DEVELOPMENT FACILITATION TEAM
SUPPLEMENTAL SUBMITTAL

PROJECT NO. 2023-009688
Application No. SI-2024-00597

SUBMITTAL DESCRIPTION: Letter Addressing Comments; Copy of Recorded Plat; Revised Infrastructure List; Landscape plan pending Review + Approval for an Alternate landscape plan; Drawings to address Comments.

Attn. : DFT Chair
Cc. : Reviewers
Re. : **SI-2024-00597 – SITE PLAN DFT**
 : **2026 Central SW**
Project No. : **PR-2023-009688**

07 NORTH EXT. ELEVATION STREET-FACING FACADE
SCALE: 1/8" = 1'-0"

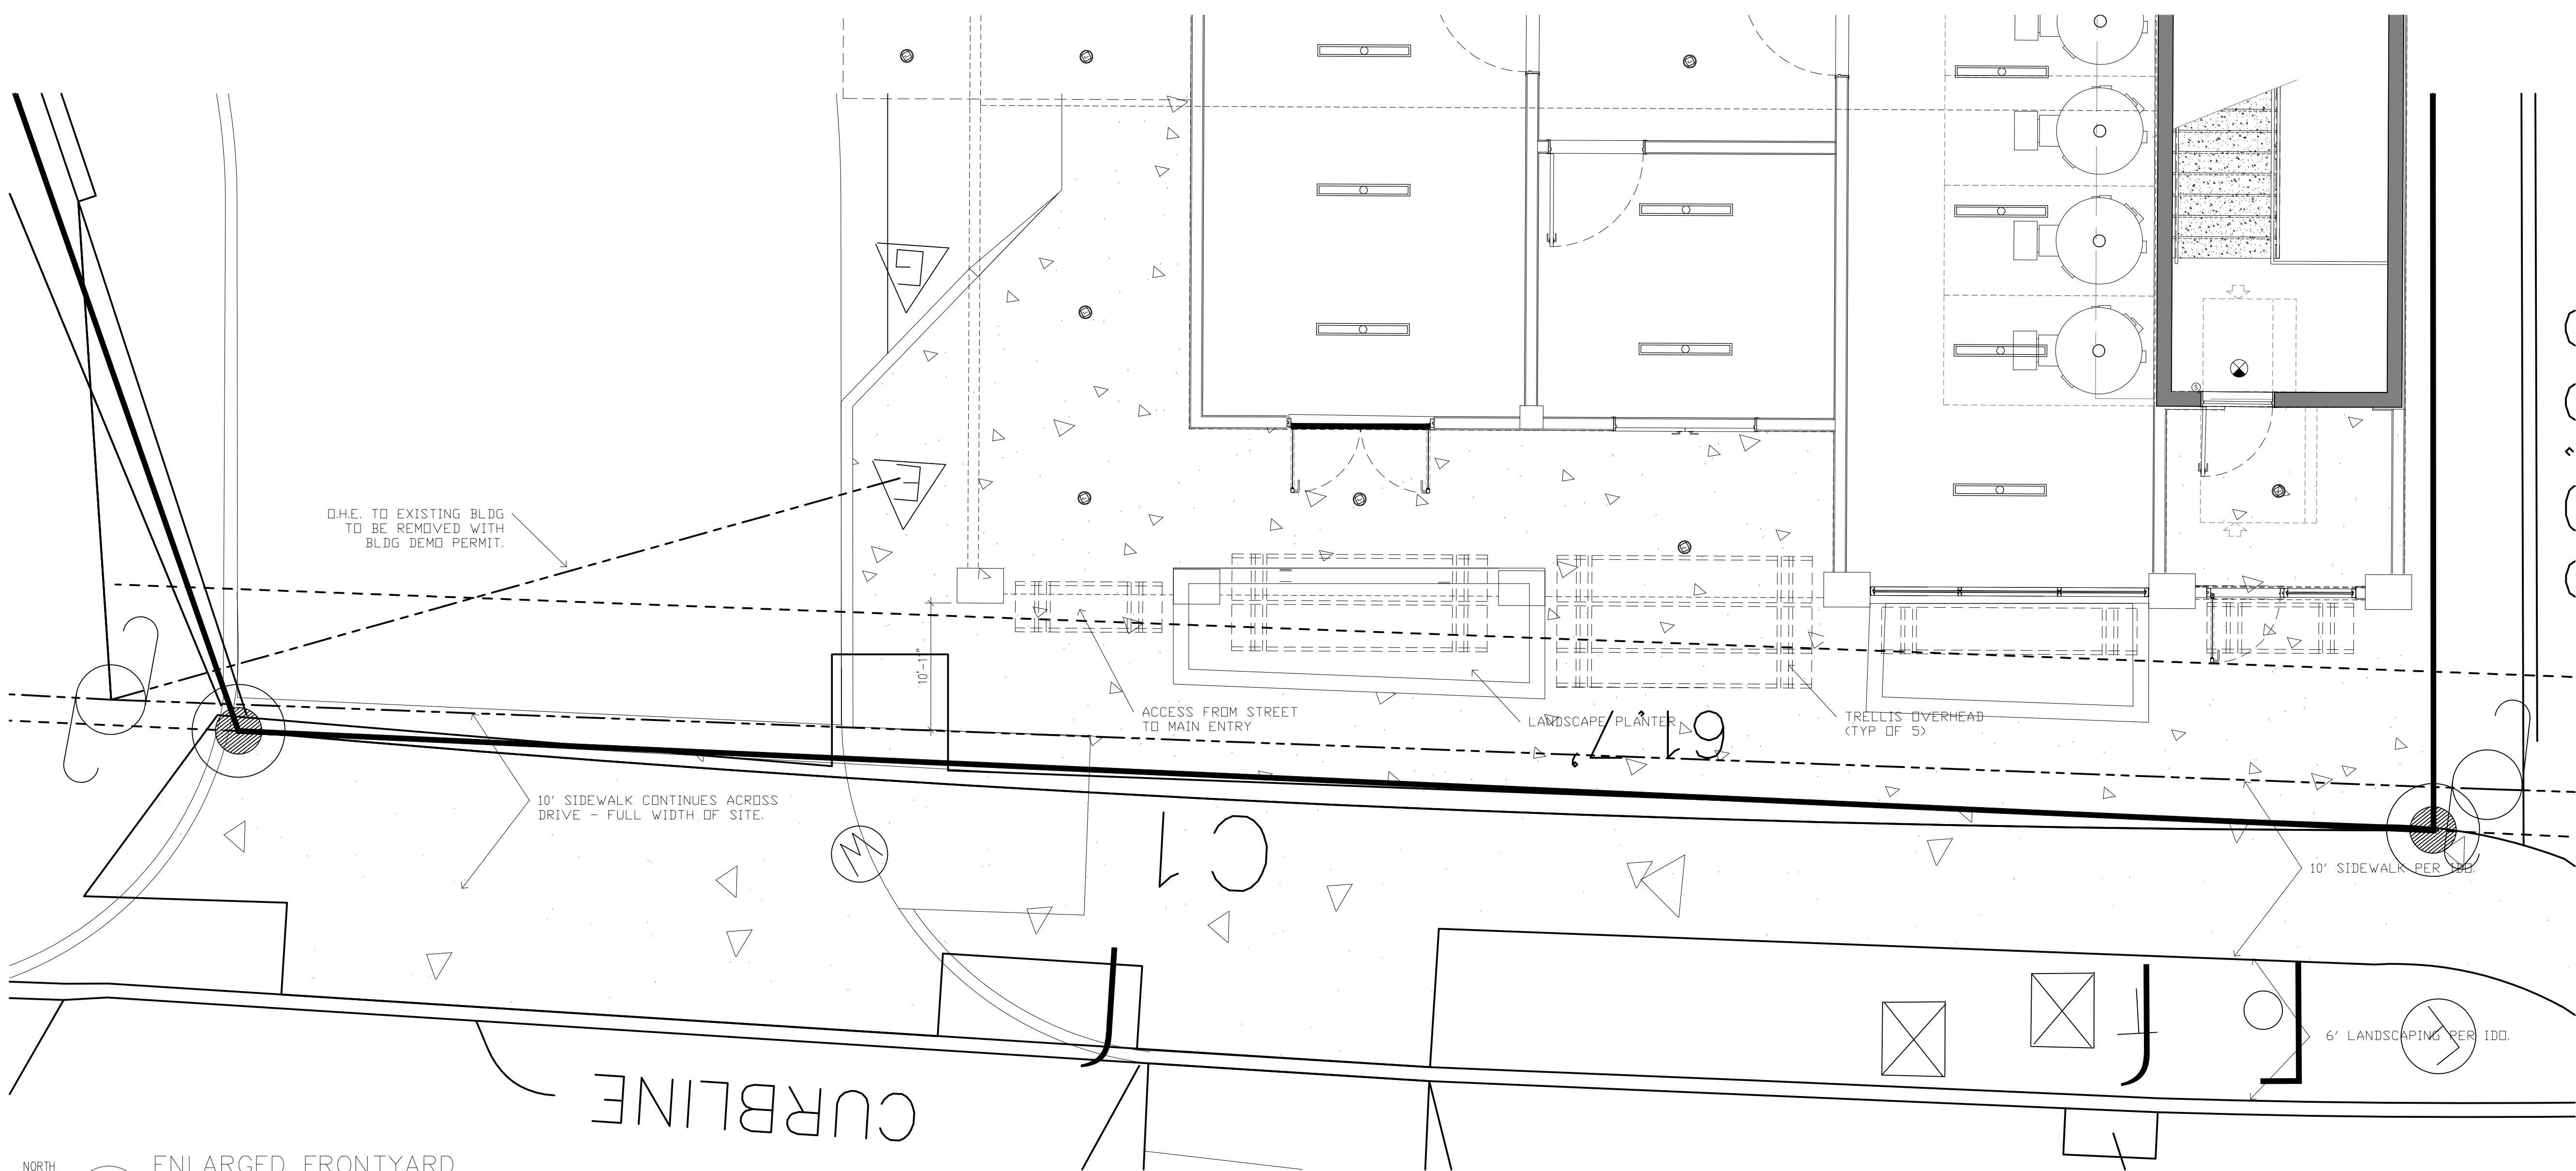
3 **Comment** -Please show calculations and/or measurements on site plan to show how you are meeting unique requirements for Urban Center, Main Street and Premium Transit Areas, IDO 5-1(D)(2), regarding (a) setback in relation to sidewalk width and (b) percent of front property line occupied by front building (see excerpt in notes, below).

12 **Comment** - 5-5(G)(3)(b) No horizontal length of any façade shall extend longer than 40 feet without the inclusion of architectural elements such as decorative grillwork, louvers, translucent screens, alternating building materials, projection of lintels, portals, and other external features to avoid visual monotony. A change in color alone does not satisfy this requirement. Confirm compliance.

Response: An enlarged area plan has been provided that illustrated the manner in which the project meets the unique requirements for UC, MS and PT Areas, IDO 5-1(D)(2), regarding (a) Setback in relation to sidewalk width and (b) percent of front property line occupied by front building.

Response: Concur. The elevations have some lintels shown, but we have added some other architectural elements in the stretches of elevation that are more than 40' to avoid visual monotony.

1 PHOTOMETRIC PLAN
SCALE: 1/16"=1'-0"

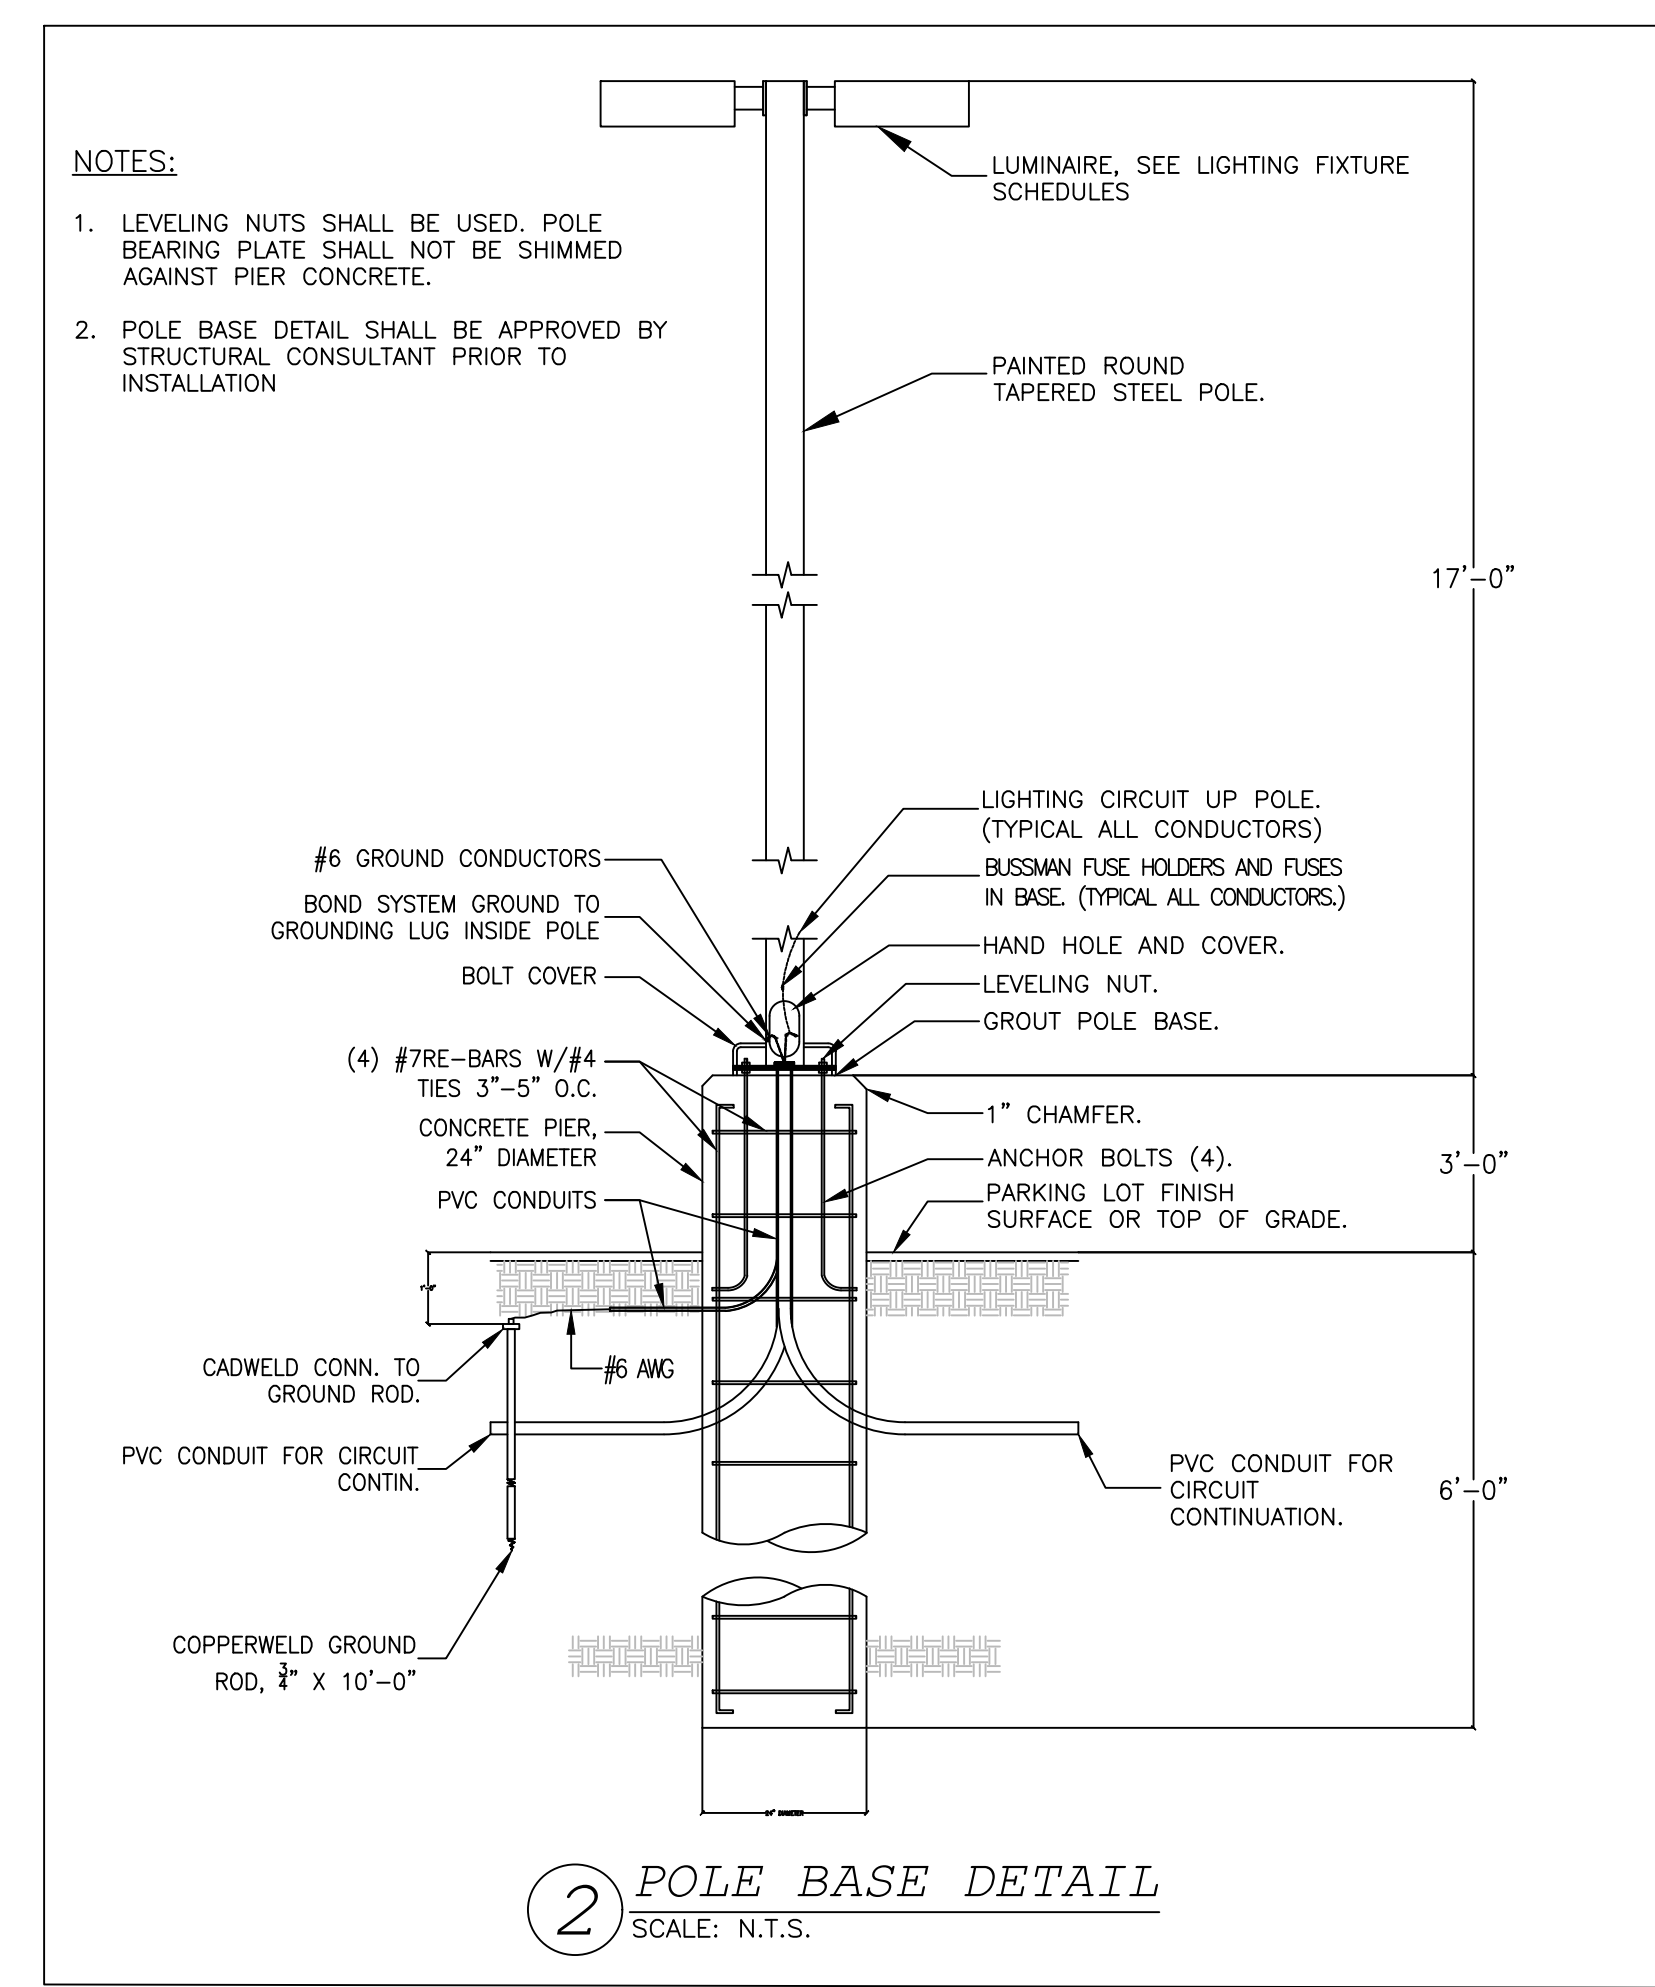
- 34 **Comment – 5-8 OUTDOOR AND SITE LIGHTING**
Please articulate how the project meets codes under this section.

Response: We have met the fc requirements of the code under this section and will submit a site photometric plan for review.

Sheet Title:
Landscape Plan
Sheet Number:
LS-01

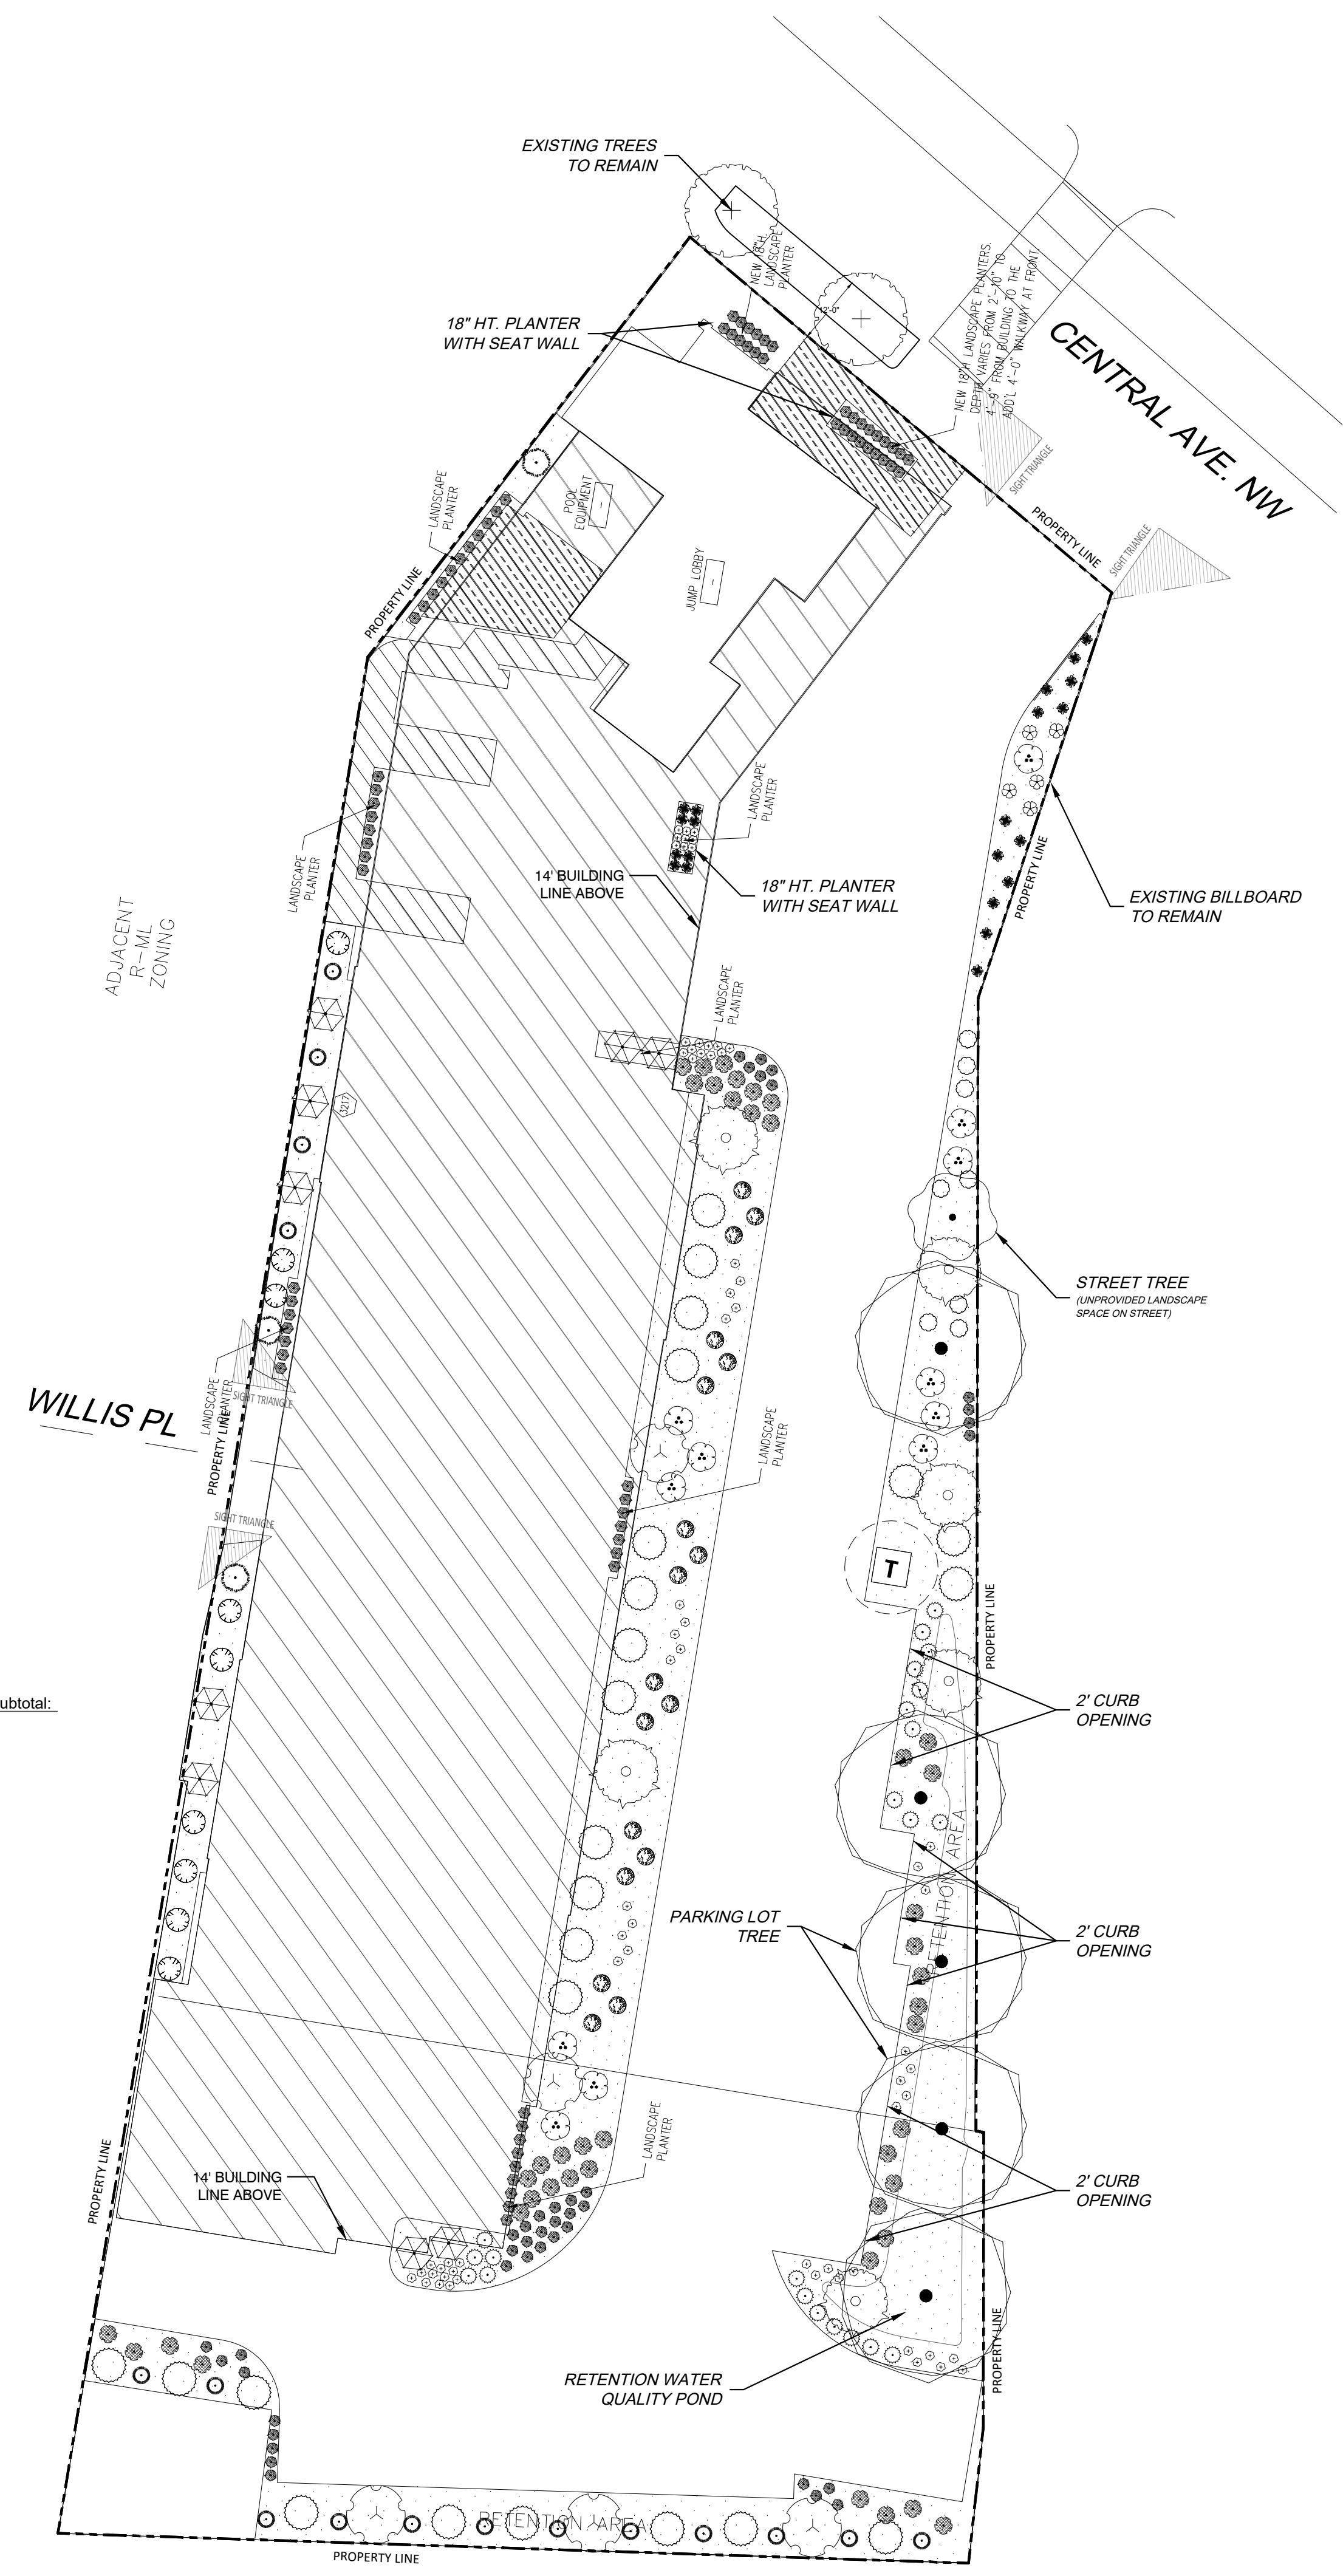
2 **Comment** - Propose larger canopy deciduous trees in larger landscaping areas to provide more shade on the hardscape. Oklahoma Redbud is generally not recommended per City Forester.

4 **Comment** - Per 5-6(C)(4)(i), shade trees planted approximately 25 feet on-center are required along all required pedestrian walkways. If the walkway is less than 25 feet long, at least one tree is required, or, where there is insufficient space for a tree, a trellis of at least 8 feet high for at least 5 feet along the walkway shall be provided. Confirm compliance.

- 11 **Comment** - The clear sight triangle shall be maintained at all exits of parking areas and street intersections. Please show the site triangle on the landscape plan and demonstrate compliance with this code.

- 13 **Comment** - Per 5-6(C)(10)(b), trees shall not be planted within 10 feet in any direction of the centerline of a sewer or water line. (See figure below.) Please confirm compliance with this code. Confirm compliance with this code.

Response: See attached landscape drawings.

Response: See attached landscape drawings that show the existing 2 trees in the front walkway area.

Response: See attached landscape drawings.

Response: See attached landscape drawings.
